Errata Sheet

October 16, 2001 / Release 1.0

Device:	SAB-C167CS-L16M 3V SAF-C167CS-L16M 3V
Stepping Code / Marking:	ES-BA, BA 6
Package:	P-MQFP-144-6

New value of the PLL jitter

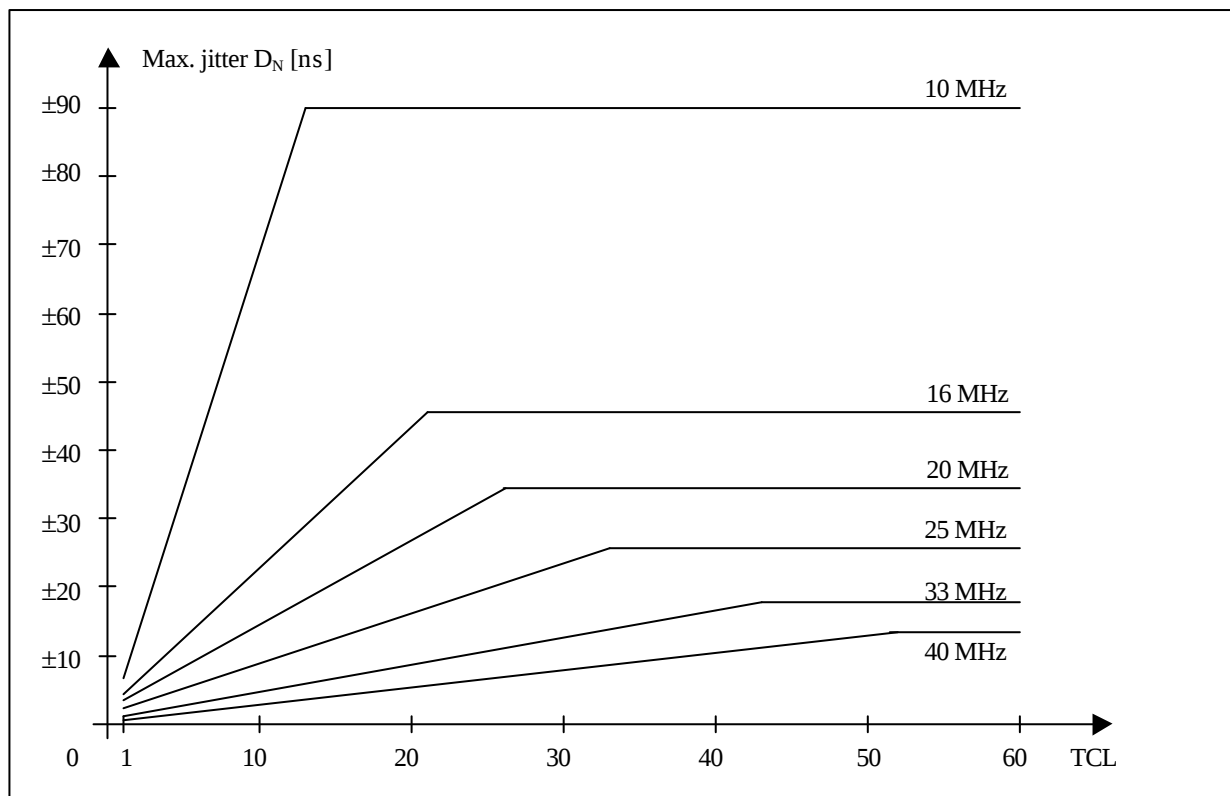
In systems where the PLL is used for generation of the CPU clock frequency, the PLL jitter can increase under certain circumstances and exceed the specified value.

The value of the additional jitter is not a fixed one but it depends on the kind of activity on the external bus or output pins. The additional jitter increases with the number of output/bus pins which are switched at the same time to a new voltage level because the problem is caused by noise on the on-chip power supply.

The additional jitter has the maximum effect if only one TCL is considered (period jitter). This can have an influence to the bus timings with one TCL.

The additional jitter decreases with the number of consecutive TCLs (accumulated jitter). The accumulated jitter has an effect on timings with more than one TCL (certain bus timings, CAN bus timing, serial interface).

For an accumulated period of $N \cdot \text{TCL}$ the new maximum jitter $D_N[\text{ns}]$, which exceeds the specified value in the Data Sheet, is computed using the formula:

$$D_N[\text{ns}] = \pm((460 / f_{\text{CPU}} + 4366 / f_{\text{CPU}}^2) * (N / T_m) + 0.25)$$

Where N = number of consecutive TCL, f_{CPU} = CPU frequency in MHz and $T_m = f_{\text{CPU}} * 1.3$.

In the case that the additional jitter causes problems in the system which cannot be relaxed with software adapted timing parameters the following workarounds are possible:

- If the clock generation is done with the on-chip oscillator then direct drive- or prescaler mode can be used.
- If the maximum frequency of the on-chip oscillator is not sufficient then an external clock generator can be used.
